KSS Knit Composite Ltd.

Client Summary Report

Observations & Actions

Medical & Baby Care Building

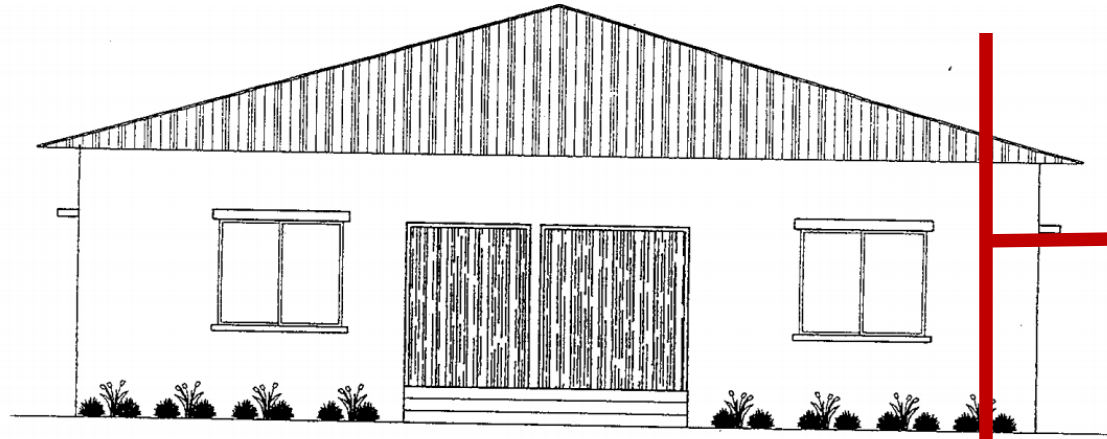
Single storied steel roof shed shown in drawing

Constructed as 2-storied RCC Building

Discrepancies between drawings provided and the as constructed building

- Engage a Building Engineer to survey the structure and prepare a full set of “as-constructed” drawings.
- Produce and actively manage a loading plan for all floor plates within the factory giving consideration to floor capacity and column capacity.
